Attachment F - Powell Fenwick Servicing Design Advice Memo

DESIGN ADVICE MEMO

Memo No **C01**
Job Name **147 Levi Road Services provisions**
Job No **240795**
Date **19 August 2024**
To **Selwyn District Council**
Address **2 Norman Kirk Drive, Rolleston 7643**
Copies to **Foodstuffs - Rebecca Parish**
Savills - Euan Gutteridge
Issued By **Ruben Thielmann**

147 LEVI ROAD SERVICES PROVISIONS

240795 - PF-CV - 00 -0101-00

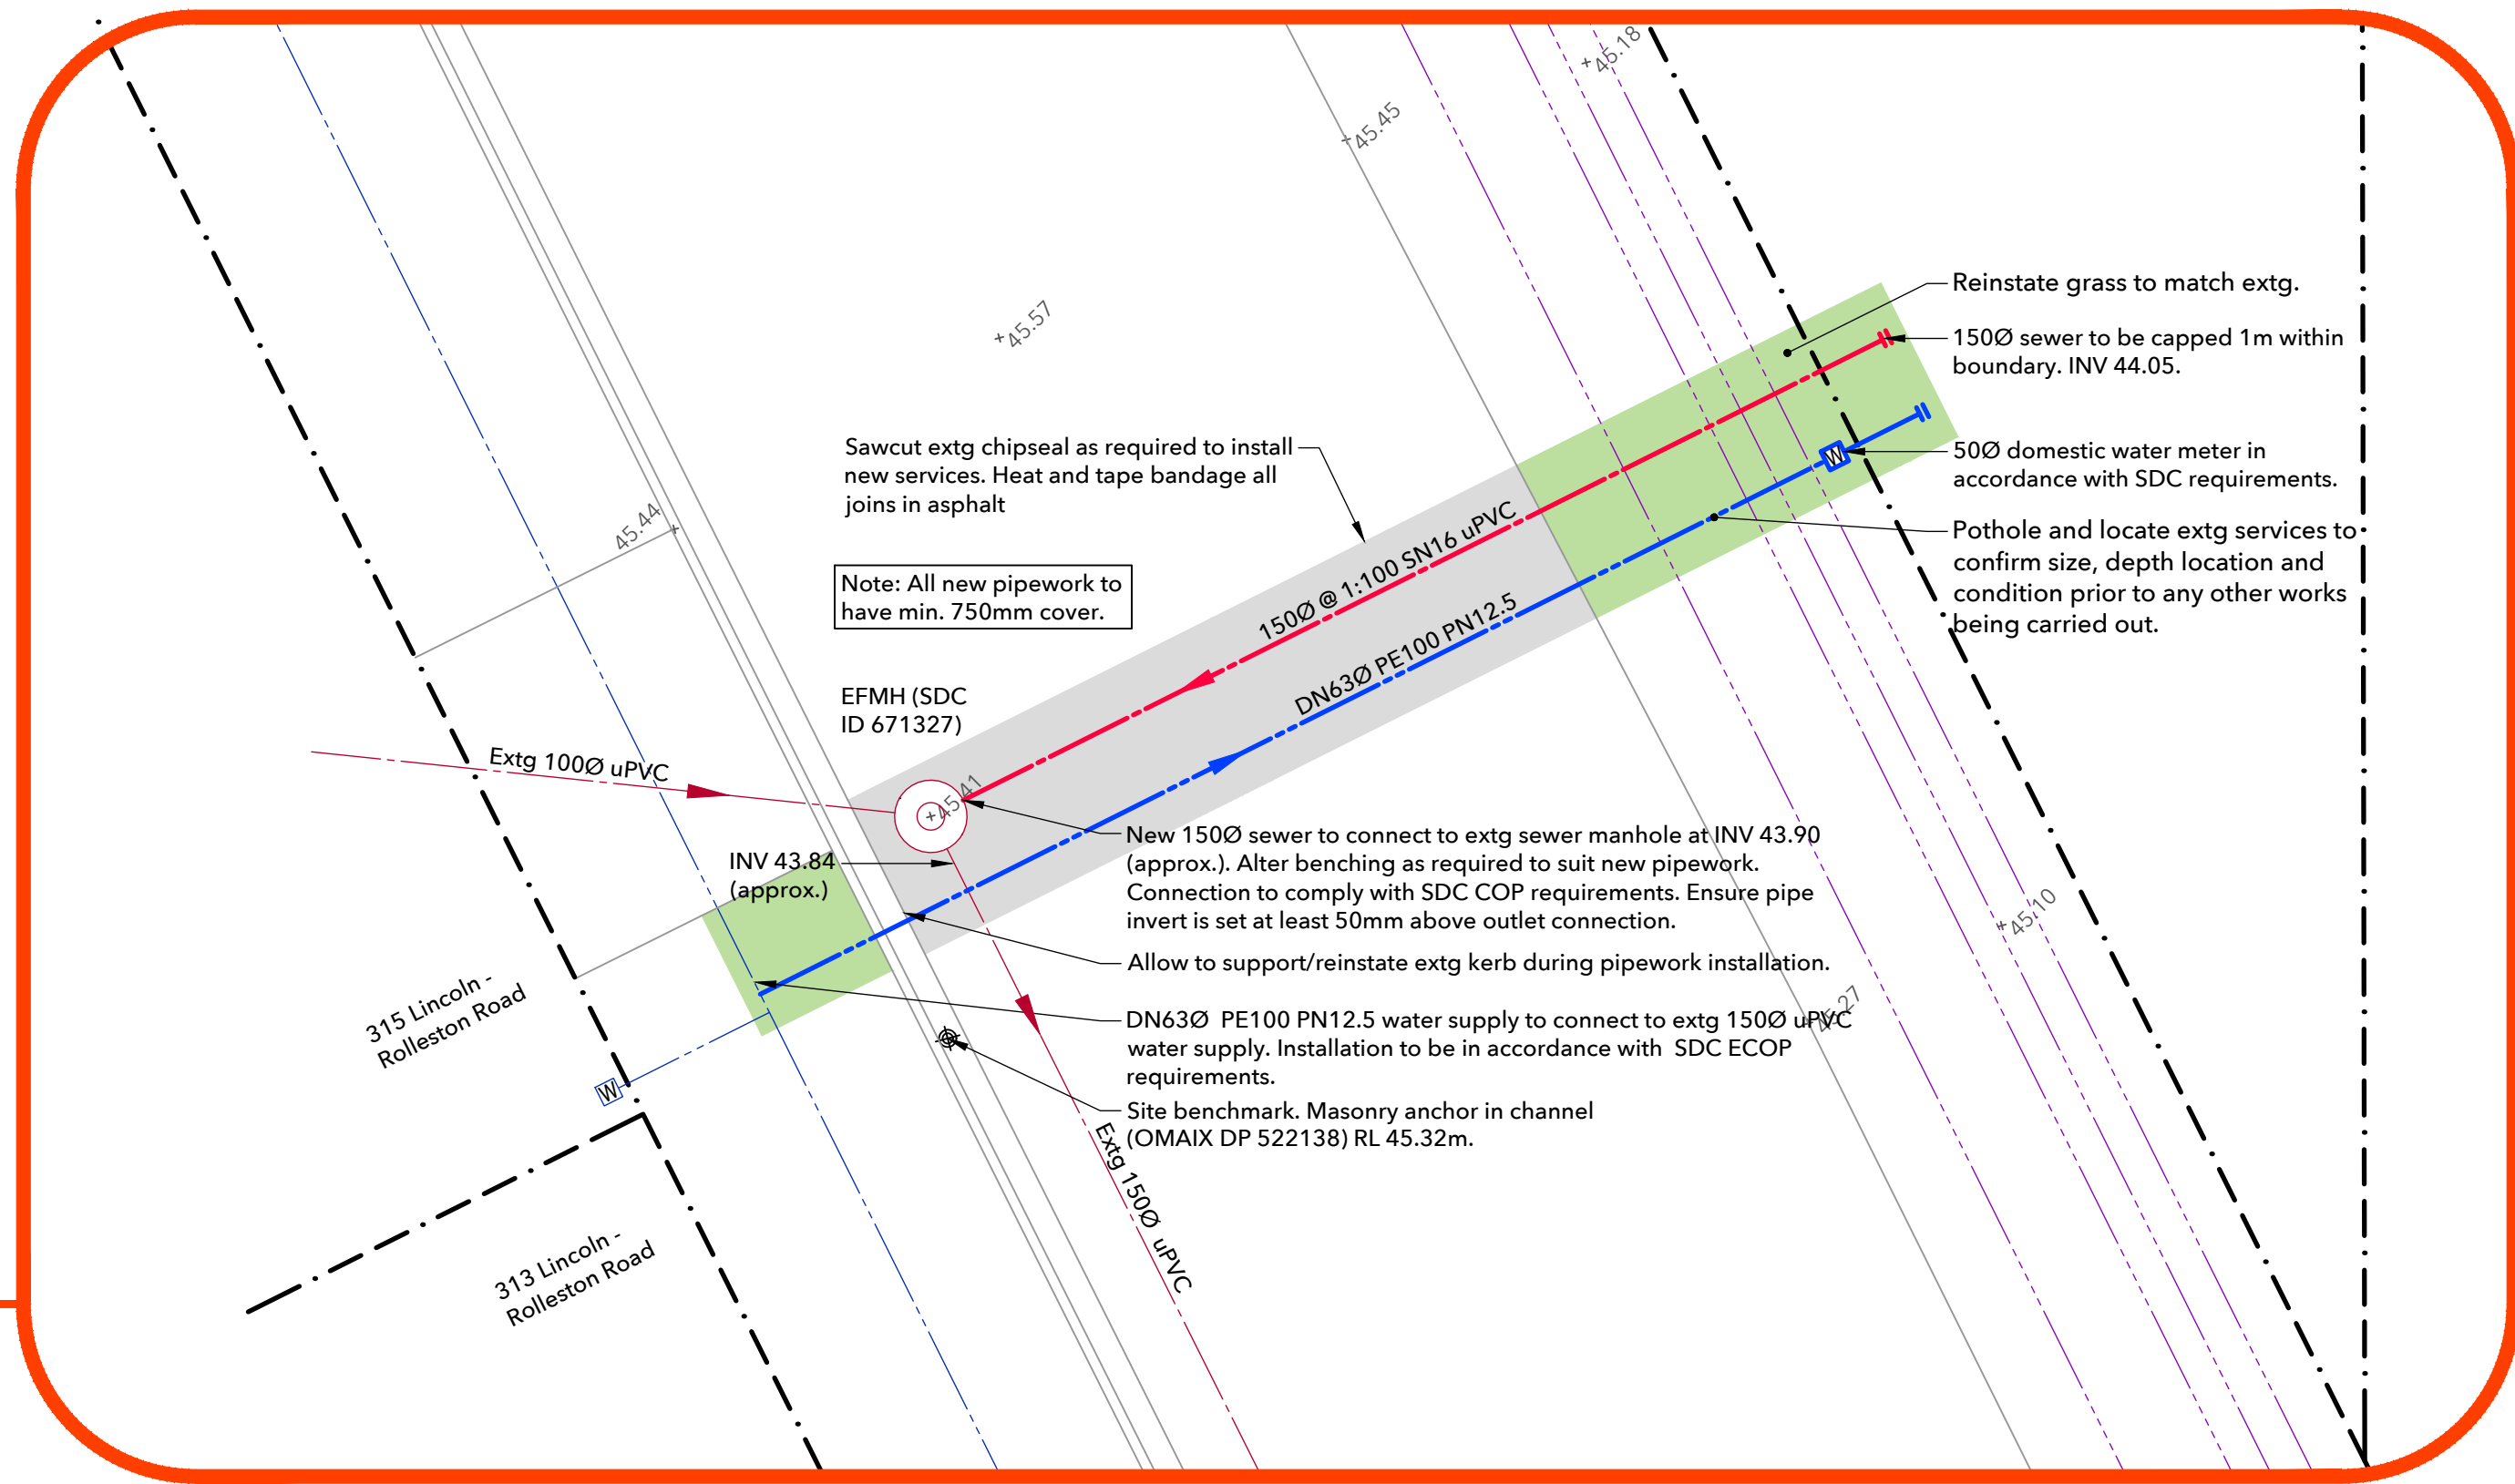
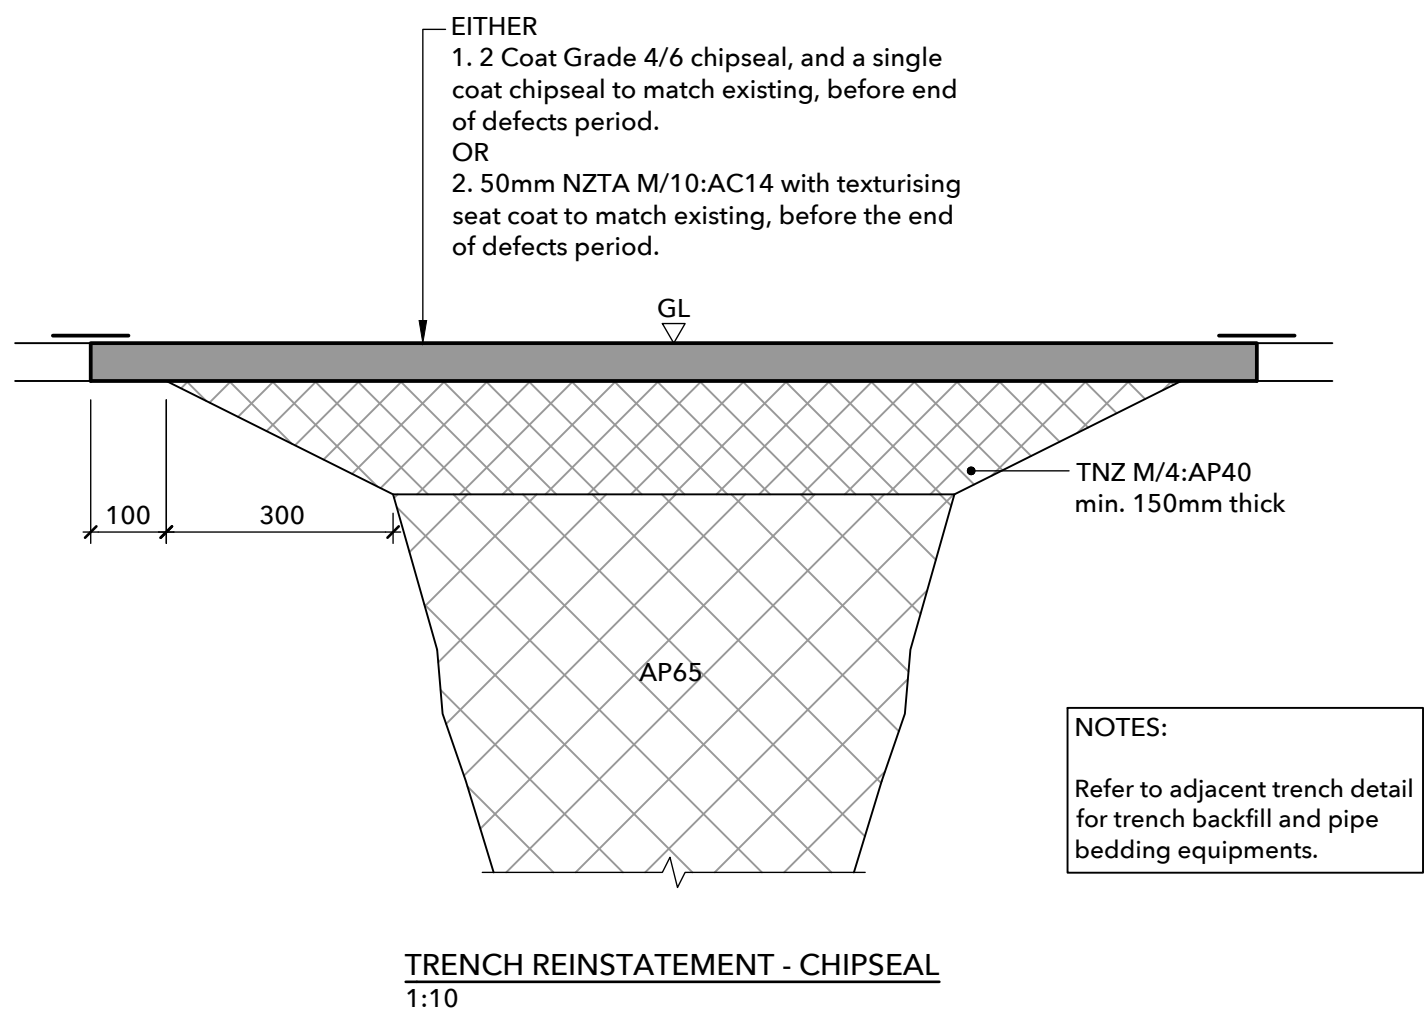
Servicing RFI 21 June 2024

In response to the RFI issued by Selwyn District Council on 21 June 2024 for the private plan change request to the Partially Operative Selwyn District Plan (V2) at 157 Levi Road, Rolleston (the Site), a memorandum has been prepared that outlines the indicative servicing arrangement for the Site to address the servicing query raised.

Existing - As indicated on the council GIS, and as shown on sheet 0101, Lincoln Rolleston Road is serviced by a 150Ø sewer that terminates at SDC sewer manhole 671327. Sewer provisions connecting the site to the council infrastructure are not currently present on site. As such, new connections to the Council sewer infrastructure would need to be established.

Proposed - The proposed development could be serviced by a new 150Ø sewer connection to SDC sewer manhole 671327. This connection would be subject to site specific design requirements and Council approvals to establish a new connection.

Existing - As indicated on the council GIS, and as shown on sheet 0101, Lincoln-Rolleston Road is serviced by a 150Ø water supply sewer that runs within the footpath on the far side of Lincoln-Rolleston Road. Water supply provisions connecting the site to the council infrastructure are not currently present on site. As such, new connections to the Council water supply infrastructure would need to be established.

Proposed - The proposed development could be serviced by a new 63Ø water supply connection to the existing 150Ø SDC water supply in Lincoln-Rolleston Road. This connection would be subject to site specific design requirements and Council approvals prior to establishing a new connection.

Fire water supply provisions for the site may or may not be required as part of the development. Provisions and requirements for these would be confirmed once the site's demand is known and would be subject to council's approval. Fire fighting water supply provisions have not been included on sheet 0101, but could be run in conjunction with the proposed domestic water supply, or as otherwise required.

Existing - As indicated on the council GIS, and as shown on sheet 0101, Lincoln-Rolleston Road (other than the sumps at the Reuben Ave intersection) is not currently serviced by a reticulated stormwater network. As such there is not suitable stormwater infrastructure into which the proposed stormwater can be connected. No known water courses or soakpits suitable for the discharge of stormwater are present within the extents of the site.

Proposed - Similar to the adjacent PAK'nSAVE development, stormwater runoff from the proposed development would need to be discharged to ground by one or more soakpits. Soakpits would be sized and positioned to suit the proposed development, with treatment systems and all other elements of the stormwater system being designed to meet the requirements of CRC241876, or a part transfer thereof.
